June 7, 2000

FROM: Tanya Eaton, John Lehning NRR/DSSA/SPLB

On Feb. 15th, 2000, the "Draft Final Technical Study of Spent Fuel Pool Accident Risk at Decommissioning Plants," was released for public comment. In a letter dated March 15, 2000, the Union of Concerned Scientists commented that the NRC staff solicited comments from the public, when it had no intention of addressing their comments. Therefore, to ensure that we address all stakeholder comments in the Final Technical Study, we have compiled a list of ALL comments which come from transcripts of meetings with the public, letters from the public, and emails received, from April 1999 until the present time.

Summary of Public Comments/Staff Commitments

FIGURE 1: Envelope Ground Response Spectra for a (principal) horizontal GM direction, relating to exceedance frequencies 10^{-5} , 10^{-6} and 10^{-7} annual events per site and damping ratios 0.005, 0.02, 0.05, 0.07 and 0.10.

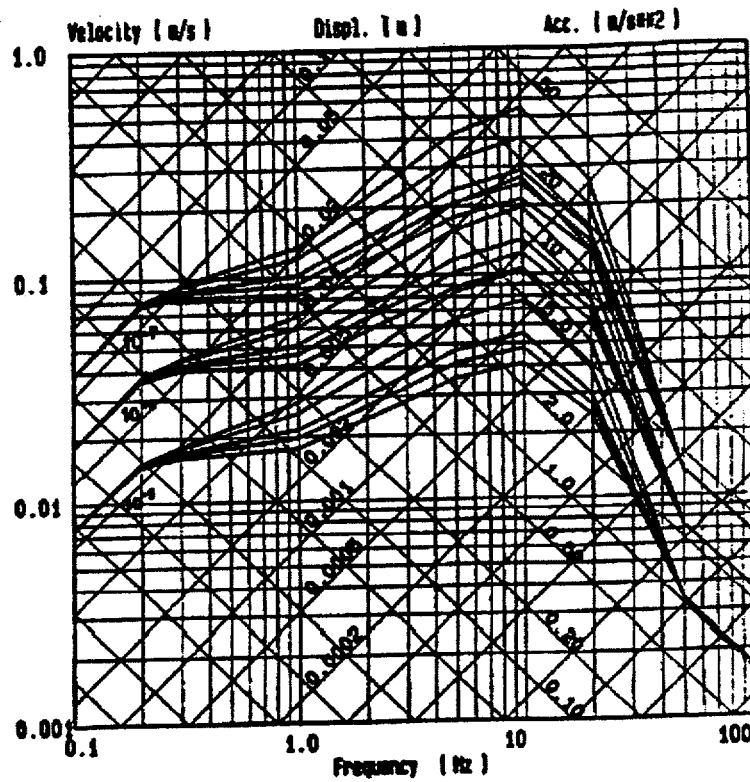
5. An US earthquake response spectra $10^{-5}/\text{year}$ ($0.5g$) is considered as a 10^{-7} in Sweden. Does this justify exemption from further consideration, due to low yearly frequency for Zr-fire? The SFP at the Swedish plant is calculated with an earthquake $0.1g$, see response spectra Figure 1, and found to comply with the Swedish standard design standard (Boverkets Konstruktionsregler 94, BKR 94
